October 11, 2023

I am writing to you as a concerned citizen regarding the request for Preliminary Approval of the proposed Subdivision Gwynn Farms Plat. **Preliminary approval is premature in light of the many unanswered questions regarding the project.**

SD23-01, a petition by Lisa Ford for approval of a Preliminary Plat consisting of 49.43 acres and 43 lots entitled Gwynn Farms which is located on C.R. 18 and shown on the location map.

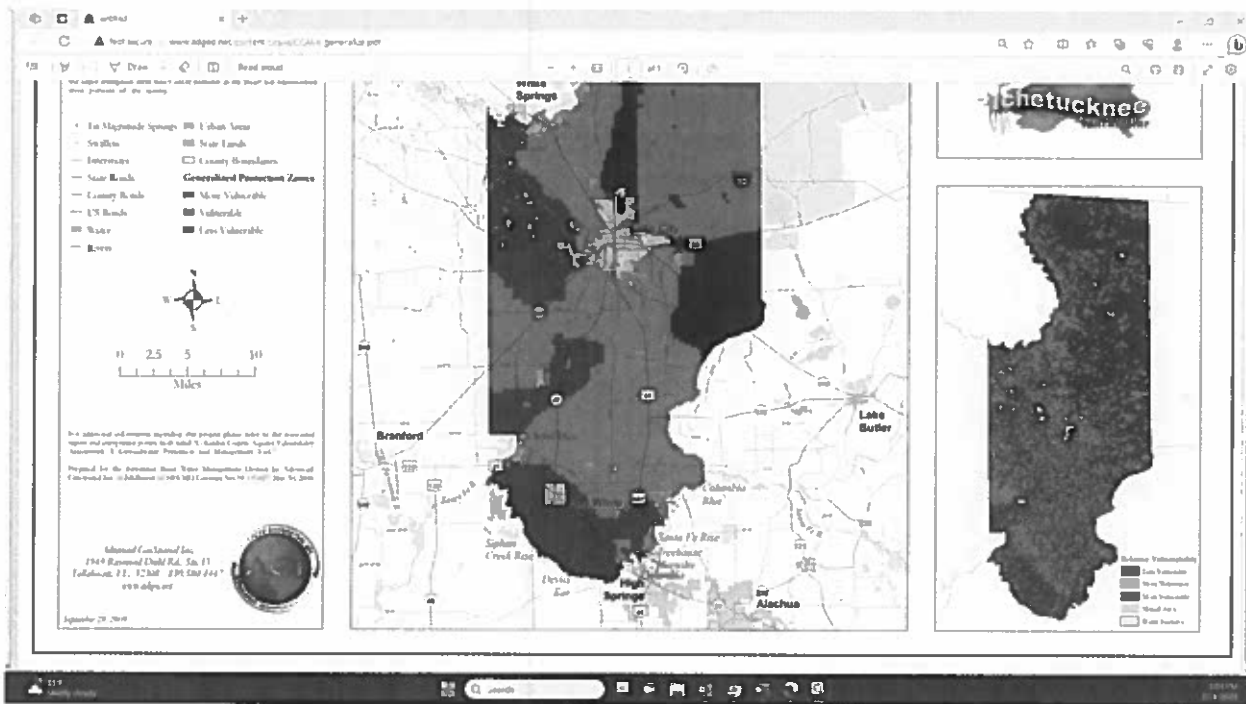
- a. **Threat to sensitive Karstic landscape** (sinkholes, subsidence areas, connection to the Devil's Ear system of springs on the Santa Fe River.) I have attached a quotation and map from a retired hydro-geologist from the SRWMD, Thomas Greenhalgh. (scroll down to end of letter to see map).

*"The proposed Gwynn Farms subdivision is in a portion of Columbia County where the Floridan Aquifer system has been determined to be the most vulnerable to contamination. The LiDAR confirms the karstic nature of the area with several sinkholes and karst depressional areas on the Lisa's Land parcel. The Outstanding Florida Springs springshed cover indicates the parcel is in the Devil's Ear Spring springshed.*

- b. Geology report. Core samples were done at the request of Lisa's Land, Inc. The report indicates that these were requested in specific areas and not necessarily on the parcel as a whole. Shallow particulate sampling was done on a broader area. In the past 15 years 2 sinkholes have opened up at the end of Paisley Court (most recently in 2011). These have been filled with truckloads of material from off site. To date one can see clear depressions in those areas. My question is, does shallow sampling of these soils provide an adequate evaluation of whether the geology will support heavy equipment, extensive digging and filling, construction of
